SUBJECT: Massachusetts Department of Transportation (MassDOT)  
Allston Multimodal Project  
Throat Area/Charles River Working Group  
Meeting Summary as of July 18, 2024

On July 16, 2024, the MassDOT team for the Allston Multimodal Project virtually held the second meeting with the Throat Area/Charles River Working Group. The Working Group discussed shoreline alternatives and parkland options.

Comments Made in the Second Session, Tuesday July 16, 2024

#### 1. Soldiers Field Road with the 40 foot width of Memorial Drive

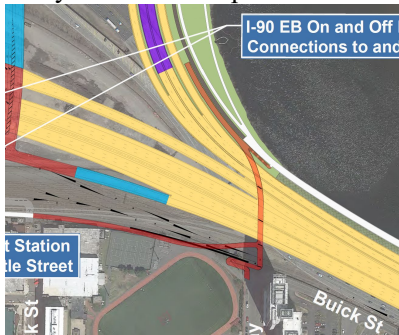
MassDOT emphasizes that Soldiers Field Road is listed in the National Register of Historic Places and that the parkway qualities of the road must be respected. According to DCR's Historic Parkway Treatment Guidelines: *"Parkways are not intended to be high speed roadways and typical posted speeds rarely exceed 40 mph"* and parkways designated for pleasure vehicles only such as Soldiers Field Road should have lanes 9-10' wide *"to slow traffic & increase safety, reclaim green*

Memorial Drive functions satisfactorily as a 40’ wide, 4 lane historic parkway. Your alternatives analysis should include Soldiers Field Road in the Allston Throat with these same dimensions instead of the 48.5’ width currently proposed.
